REMARKS

Application No. 10/618,914
Amdt. dated May 17, 2005
Reply to Office Action of February 17, 2005

Amendments to the Drawings

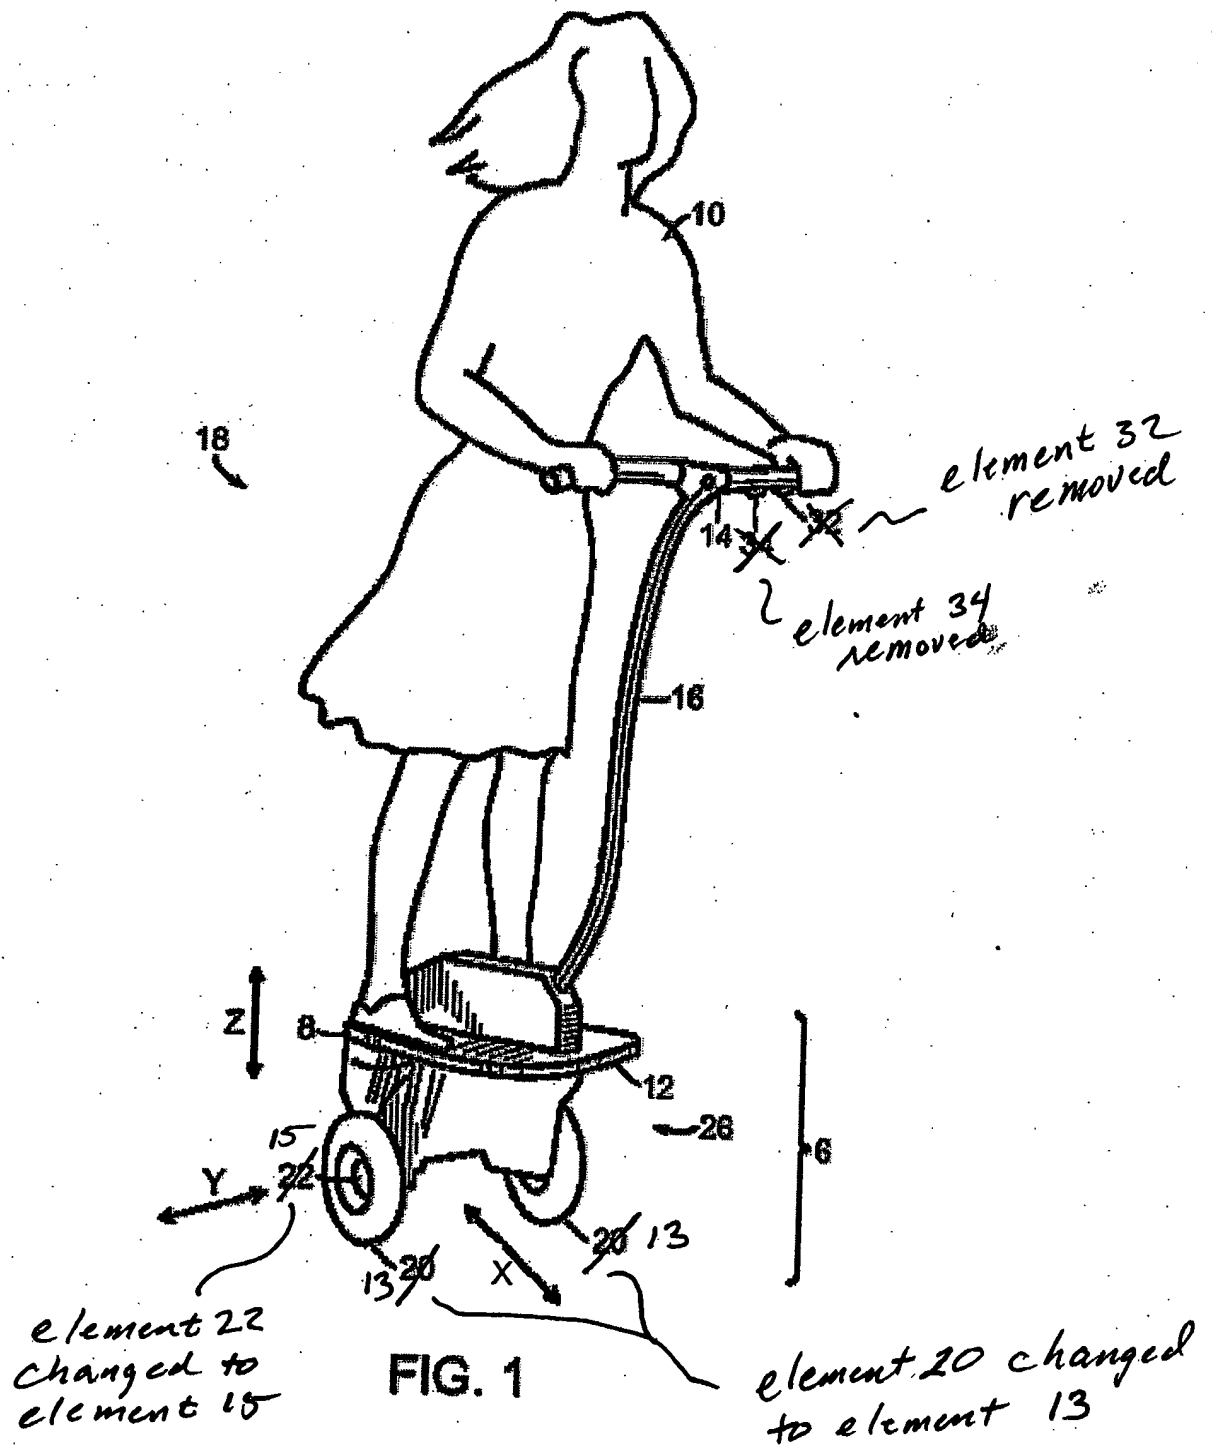
In response to the notification in the Office Action that certain reference numerals were either missing from or redundant in Figures 1 and 2, Applicants submit herewith amended Figures 1 and 2 with corrected and removed reference numerals, respectively. No new matter has been added and approval of these amended figures is respectfully requested.

The attached sheets of drawings include changes to Figs. 1 and 2. These sheets replace the original sheets that included Figs. 1 and 2. In Fig. 1 reference numeral 20 was changed to 13, reference numeral 22 was changed to 15, and reference numerals 32 and 34 were removed. In Fig. 2 reference numeral 12 was removed.
